Revision

SLAB BOX FOR THREE PHASE TRANSFORMERS SB-2, SB-3

UGS

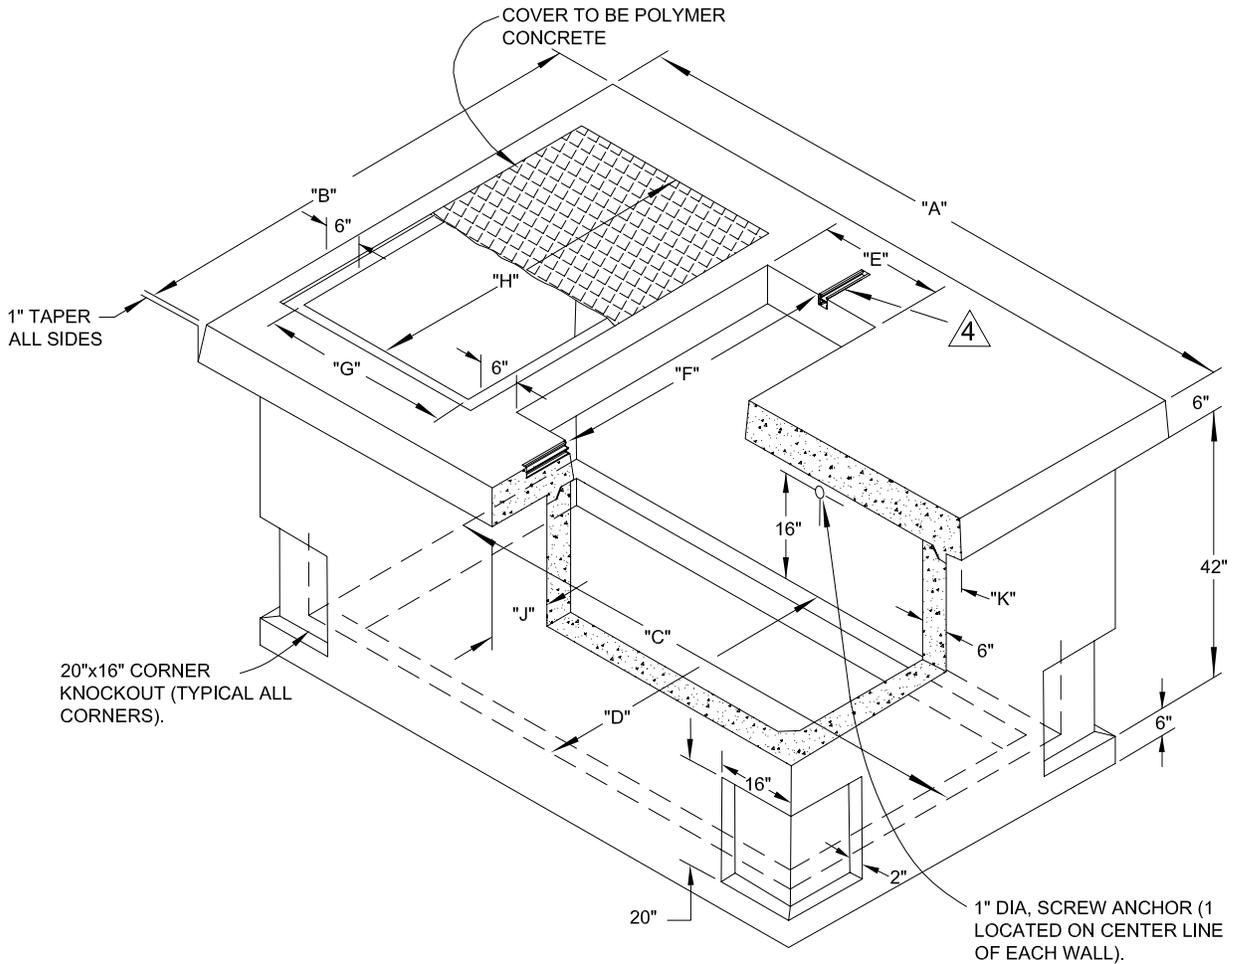
REVISION: Included Unistrut

1. See UGS-723 for installation of SB-4 Slab-boxes.
2. See UGS-010 for manufacturers of precast slab-boxes and catalog numbers.
3. All slab boxes shall be furnished with a polymer concrete cover with stainless steel, penta head cap screws for cover securing.
4. Polymer concrete covers are to be identified as "RIVERSIDE ELECTRIC" as per UGS - 050.
5. Grade rings may be used when required. Maximum allowable are 12" grade rings.
6. Slab boxes shall have a precast unistrut to anchor the transformer cabinet.
